PACKAGE 3.2

POWER DISTRIBUTION LIMITS

PRAIRIE ISLAND NUCLEAR GENERATING PLANT UNITS 1 AND 2

Improved Technical Specifications Conversion Submittal

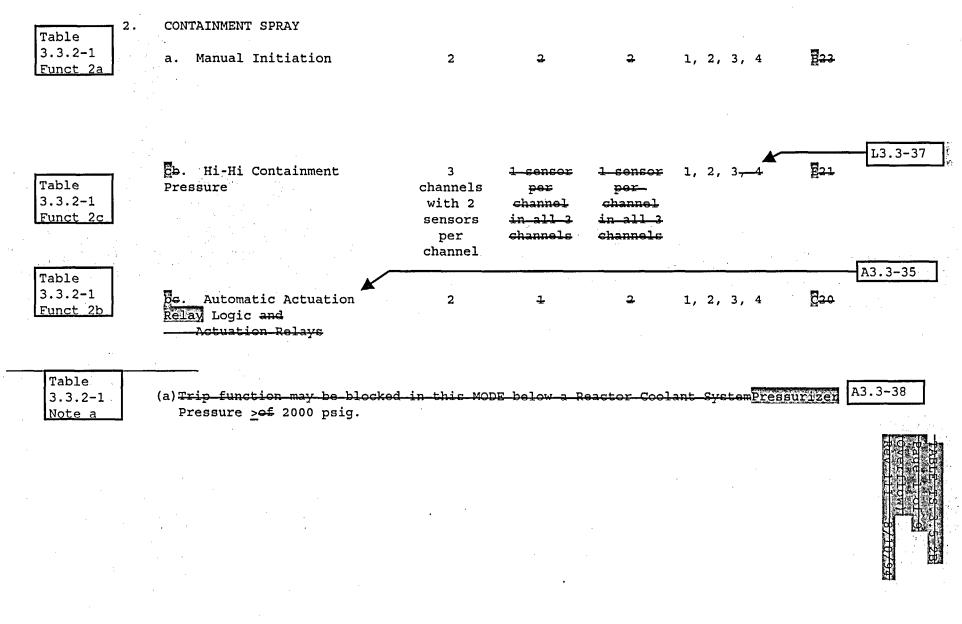
[A3.3-05
		. ↓				A3.3-06
		REQUIRED	CHANNELS	MINIMUM CHANNELS	APPLICABLE	L
	FUNCTIONAL UNIT	NO. OF CHANNELS	TO_TRIP	OPERABLE	MODES	ACTION
1.	SAFETY INJECTION					
Table 3.3.2-1 Funct 1a	a. Manual Initiation	2	1.	3	1, 2, 3, 4	A3.3-07
Table 3.3.2-1 Funct 1c	2 5. High Containment Pressure	3	2	2	1, 2, 3, 4	L3.3-36
Table 3.3.2-1 Funct le	ge. Steam Line Low Pressure	3/Loop	2-in-any Loop	2/Loop	1, 2, 3 ^(a)	<u>D</u> 24
Table 3.3.2-1 Funct 1d	d. Pressurizer Low Pressure	3	2	2	1, 2, 3 ^(a)	D24
Table 3.3.2-1 Funct 1b	e. Automatic Actuation Relay Logic-and Actuation Relays	2	1	<u></u>	1, 2, 3, 4	<u> 명</u> 구 1
			•			TABLE TS.3.5=2B (Page 1-0f-9) REV 111-8/10/94

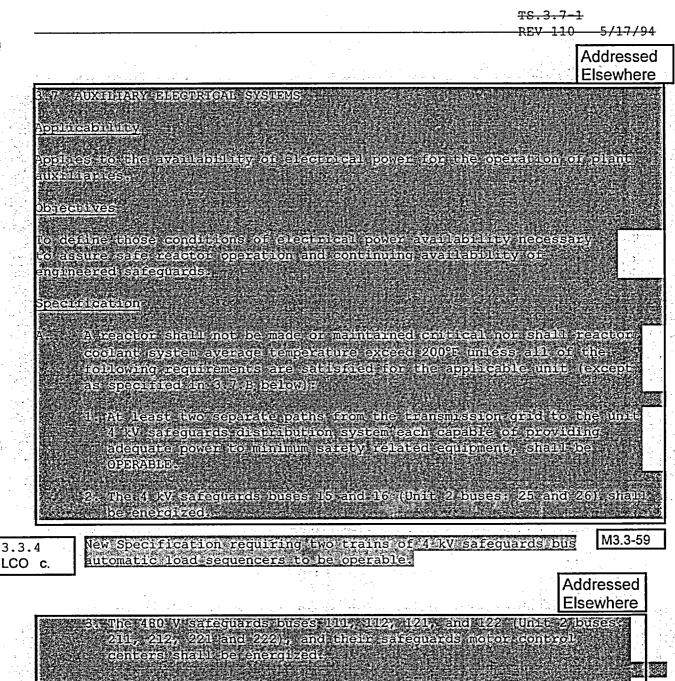
CTION-36:Two channels may be inoperable for up to 1 hour for surveillance-testing per Specification-4.1.---Restore at least one channel-to operable status within-this 1 hour or initiate the action necessary-to-place the affected unit in HOT-SHUTDOWN, and be in at least HOT-SHUTDOWN within the next 6 hours and-in-COLD SHUTDOWN within the following 30 hours.
